Cable route in stages Image 2 Image 3

Response to Landscape Architect comments.

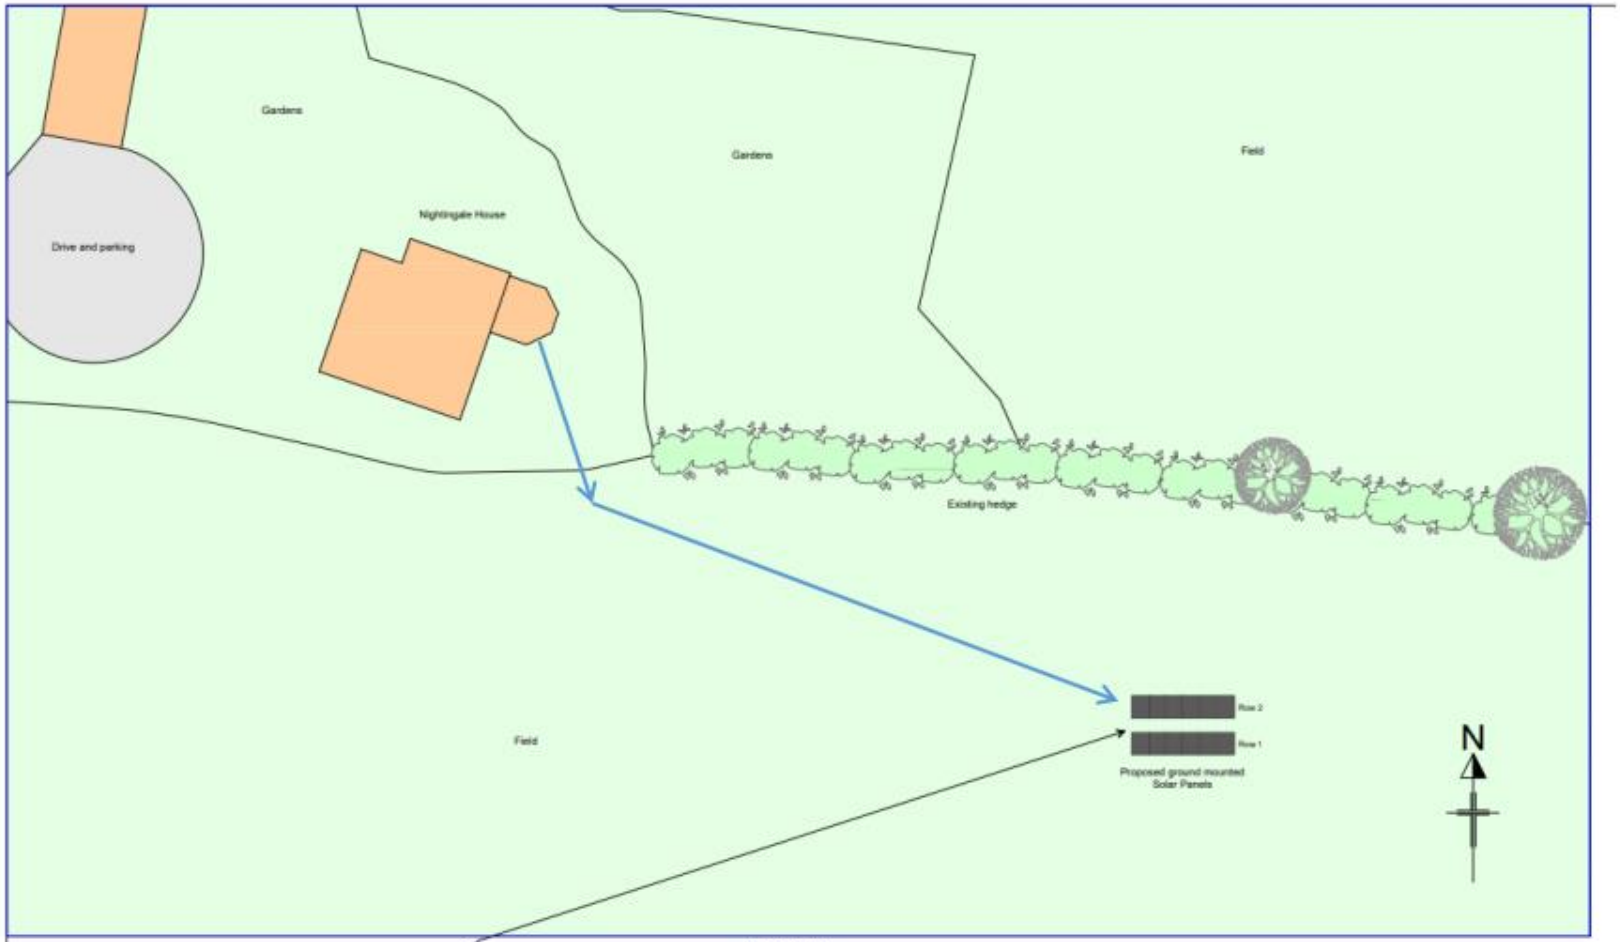
We accept that solar panels on an undeveloped field within a rural setting will add a modern/urban aspect to the area, however the field is unused, a small section of the land is proposed for this project – less than 25m2, this parcel of land will be perfect for a ground mount solar system with no shading and the ability to be south facing.

Once the panels are in-situ they will be barely visible. The views of the system from the surrounding area, if any, will be minimal and will therefore have little impact on the visual amenity of the area. As per your Public Rights of Way map on your website, there are no PROW's on or near the proposed site. There are no hedges or trees affected by the ground mounted units, by their very nature wildlife can exist around these units.

- The cable trench of depth 50 cm & width of 30 cm and will be backfilled. with the existing materials. Suitable Armoured cable is used.

The Cable run will be a 1 day install, no ground is left open, or equipment left onsite overnight.

The panels non ground penetrating, weighted mounts and are removable when no longer needed.

The systems are installed in such a way that at the end of the lifespan of the panels they and the associated equipment can be removed, and the land will be returned to its original condition. The proposed system has the potential to contribute almost 20% of the property's electricity supply and reduce the Carbon Footprint by 2000Kg/CO2 per year.

The positioning of the system will ensure the optimum performance of the panels. The option of installing the system in the residential curtilage, whilst feasible, would reduce the performance of the system due to the different orientations and the potential shading from the surrounding treeline & buildings.
